Subject: AP1000 COL Response to Request for Additional Information (TR 36)

Response to Request for Additional Information on Technical Report No. 36

RAI Response Number: RAI-TR36-012

Figure 6.3-1 DEDVI Break, RCS Pressure

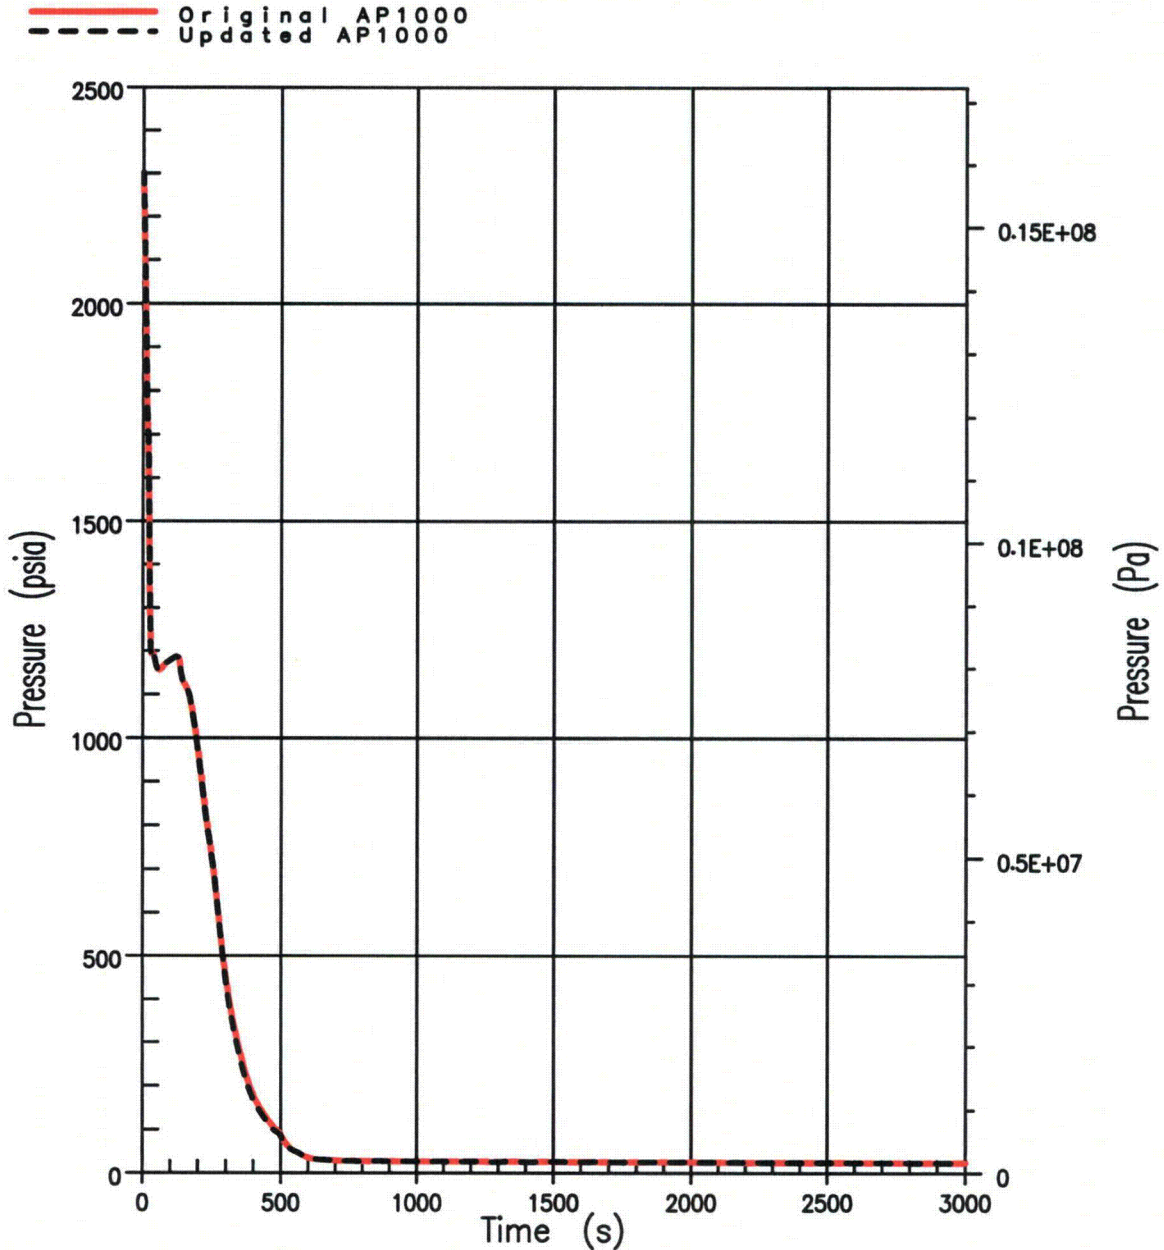
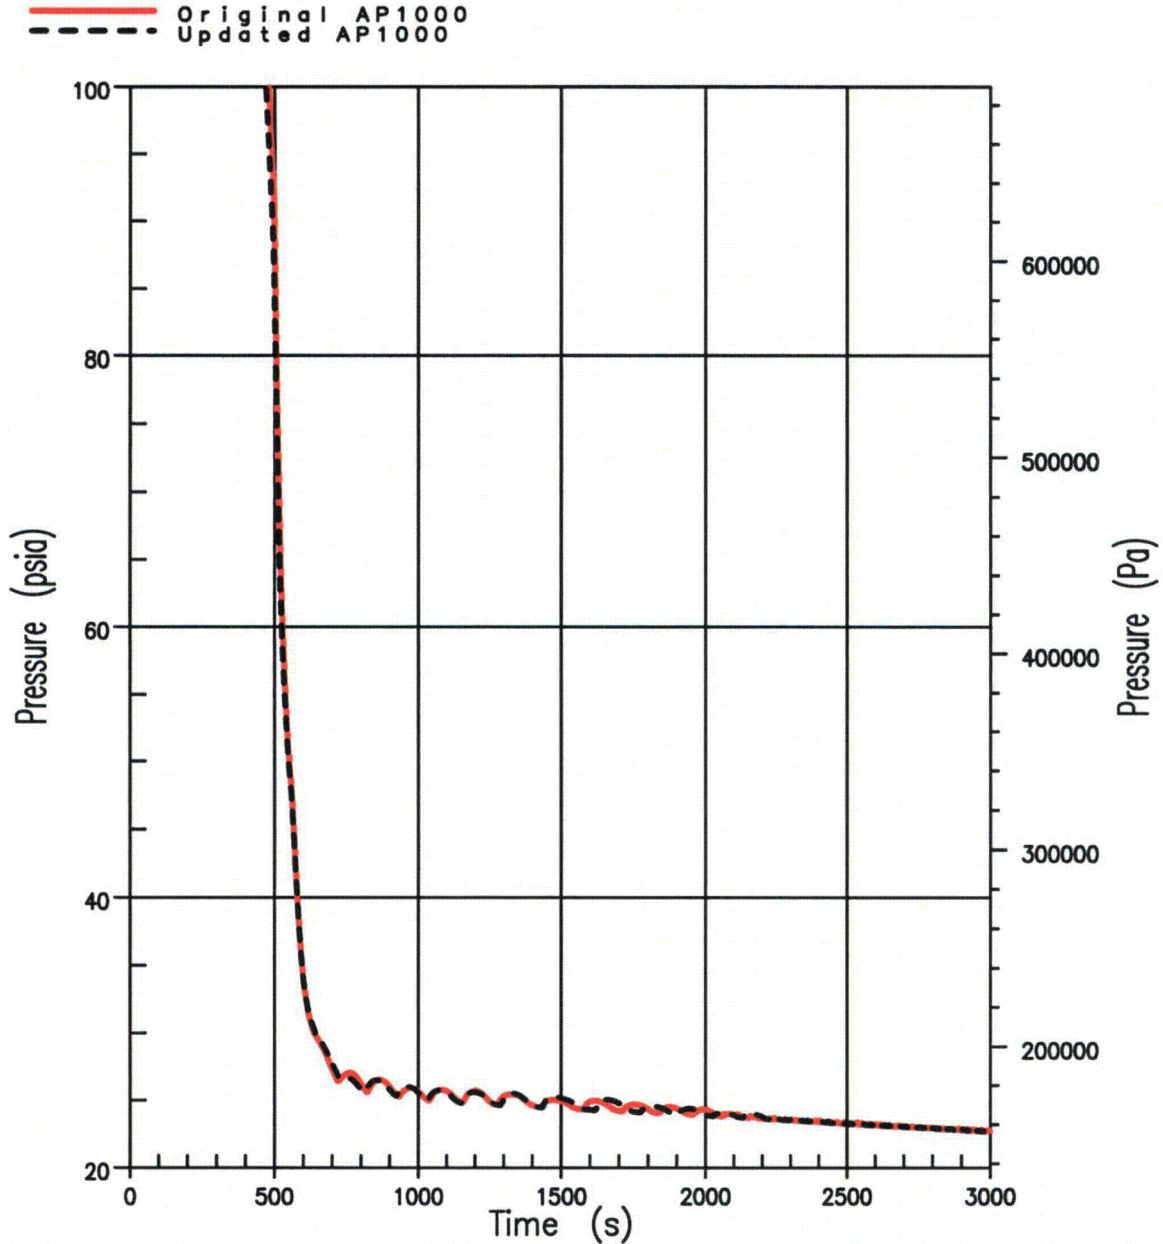
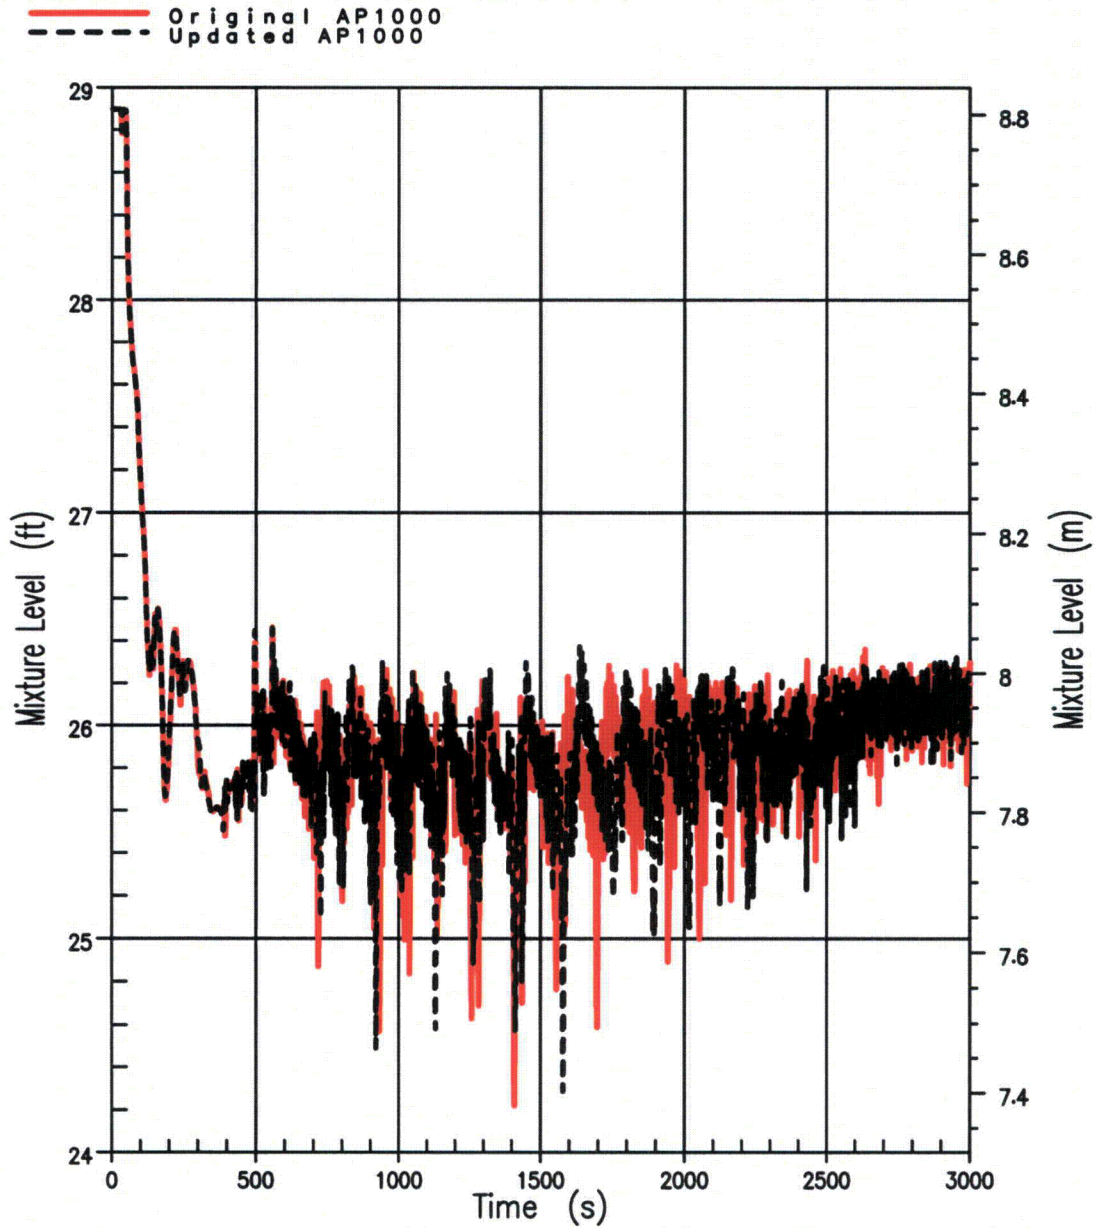
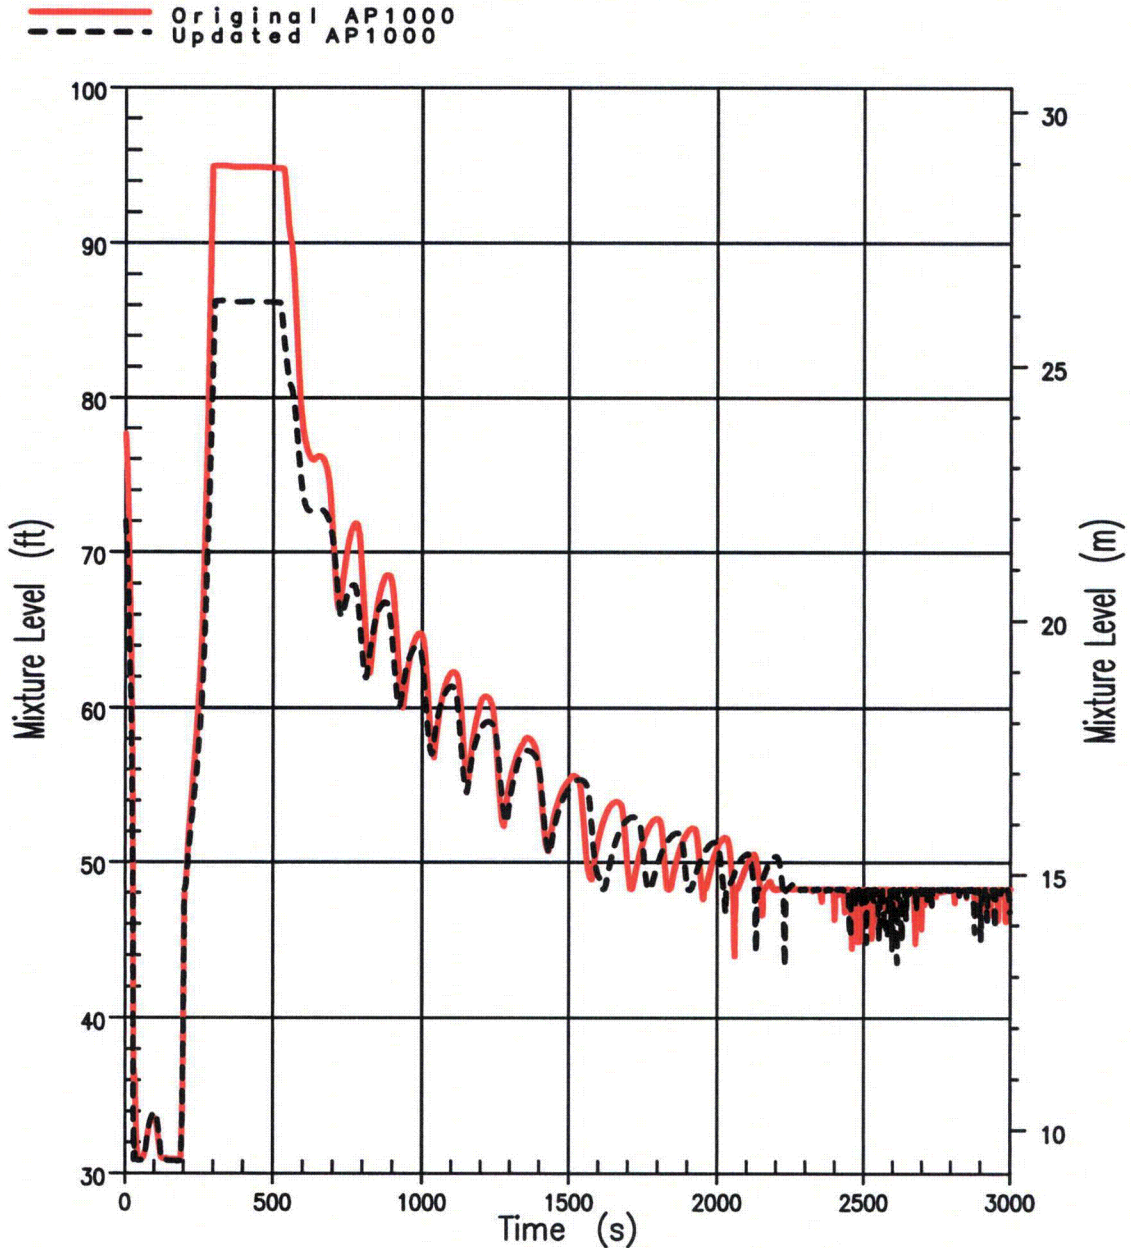
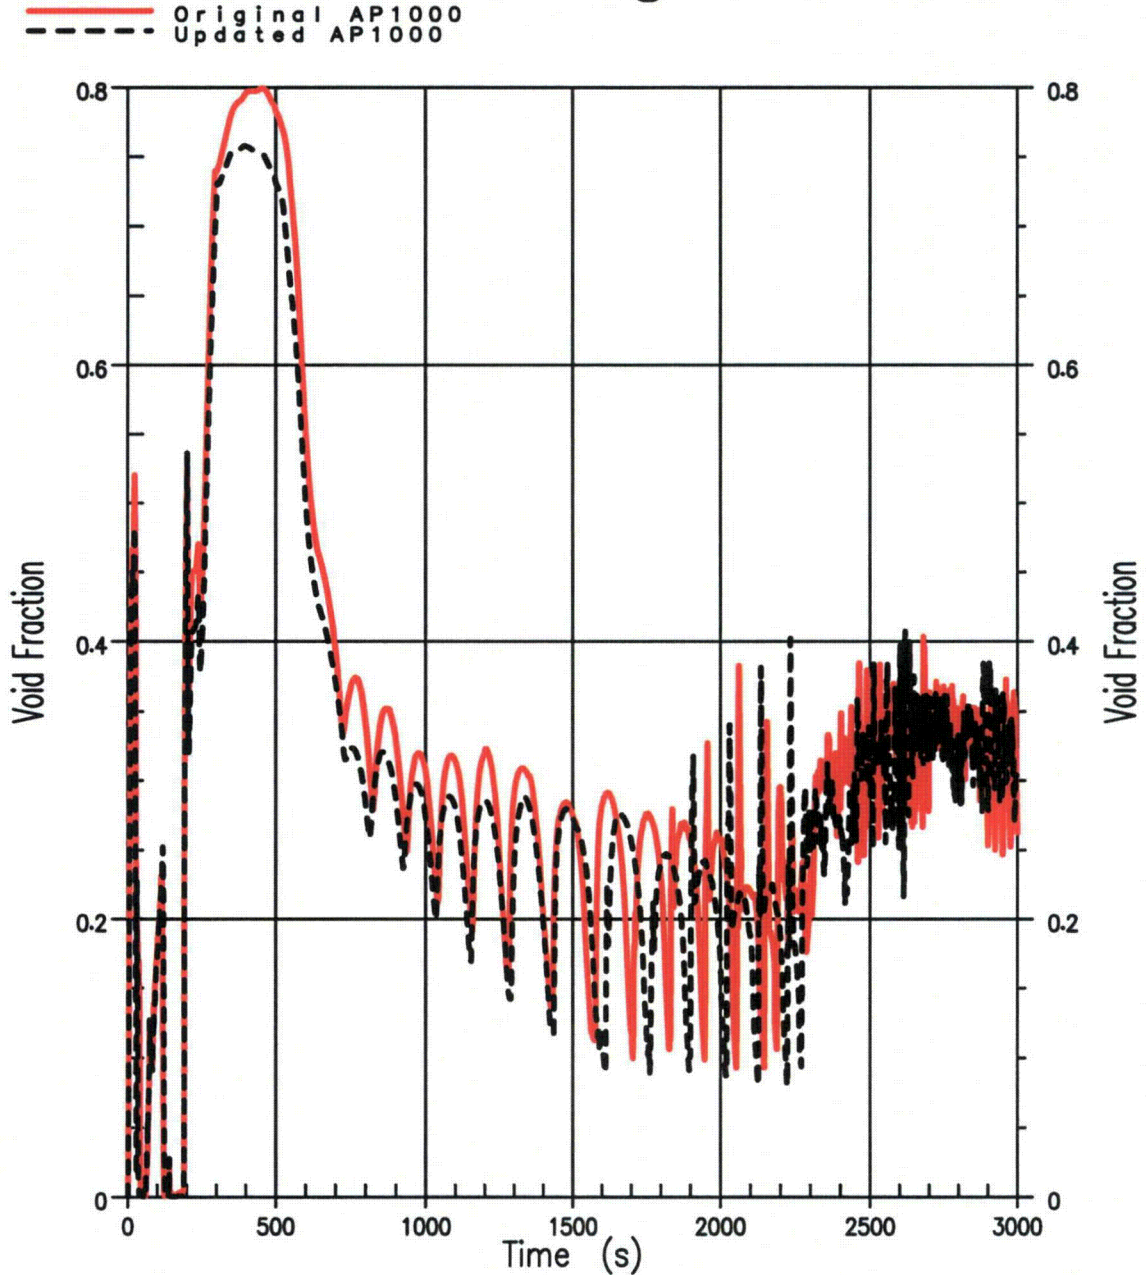
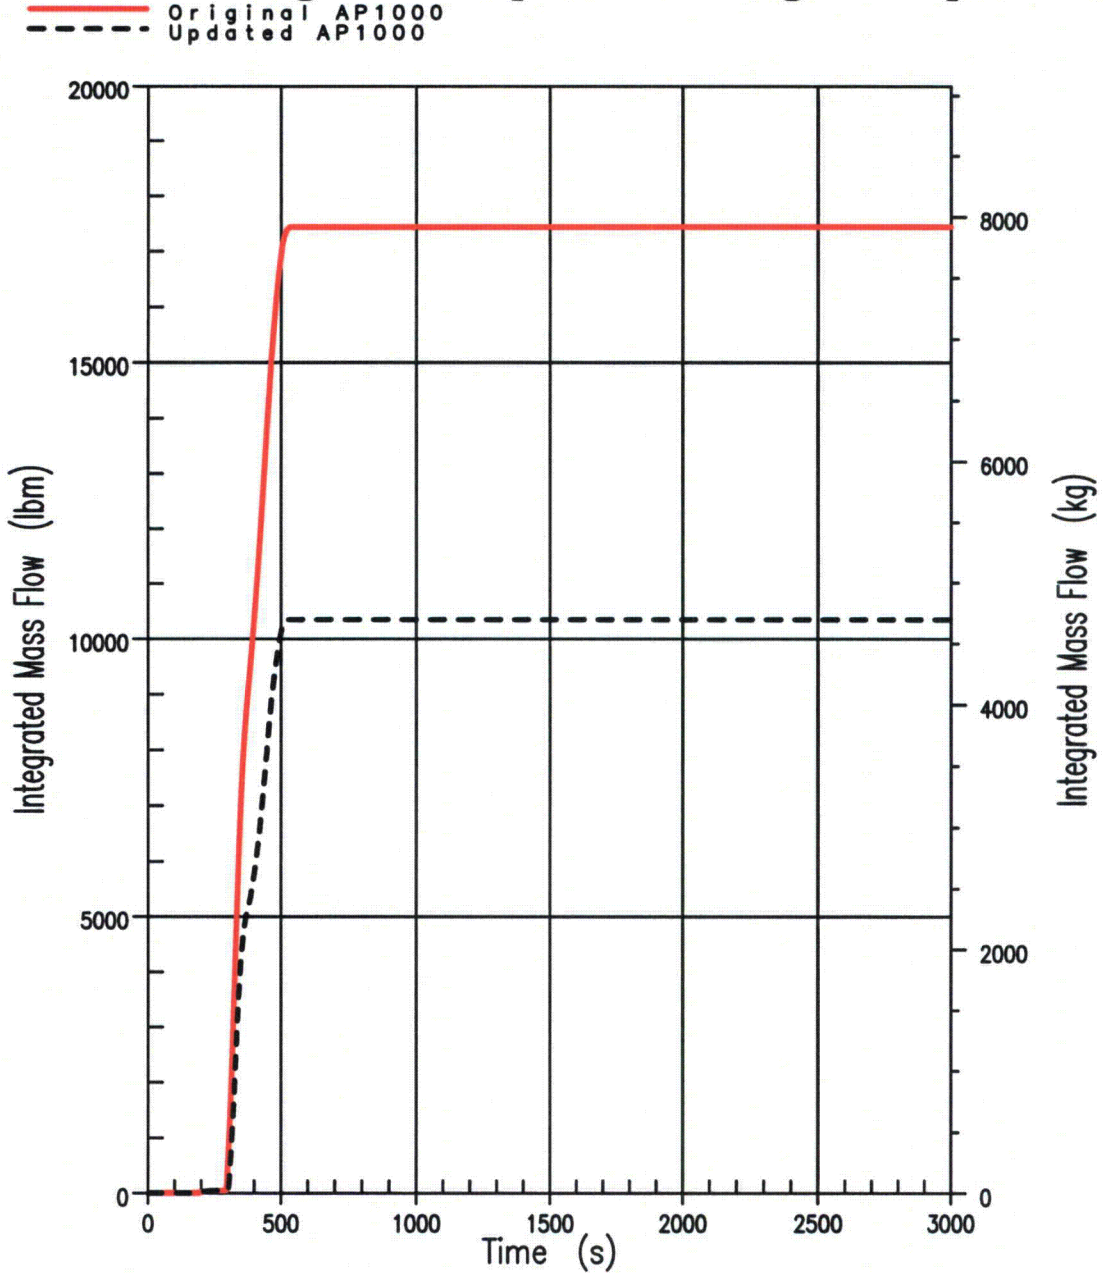
The pressurizer changes affect many parameters such as the cross-sectional area of the pressurizer, pressurizer vessel height, initial pressurizer water level, pressurizer setpoints, ADS stages 1, 2, and 3 elevation and pressurizer heater length. We are concerned about the combined effects of the values changed for the above parameters on the thermal hydraulic response during transient and accident conditions. We determined that the qualitative statement in the RAI response is not sufficient to resolve the RAI issue. We request Westinghouse perform the quantitative analyses for the limiting event for each of the following Standard Review Plan chapter 15 event categories:

Table 6.3-1 and Figures 6.3-1 through 6.3-9 present a comparison of the DEDVI line break simulations. The results demonstrate the effect of the change in the pressurizer tank diameter, that being the decrease in both the Pressurizer Mixture Level (Figure 6.3-4) and Pressurizer Void Fraction (Figure 6.3-5). This subsequently reduces the Automatic Depressurization System (ADS) Stage 1-3 liquid discharge (Figure 6.3-6) and increases the ADS 1-3 vapor discharge (Figure 6.3-7). The overall effect is that slightly more Reactor Coolant System (RCS) inventory remains in the RCS for a majority of the transient simulation period (Figure 6.3-9). No significant changes in the RCS Pressure (Figures 6.3-1 and 6.3-2), Core Mixture Level (Figure 6.3-3) and DVI injection characteristics (Figure 6.3-8) are observed as a result of the design change implementation.
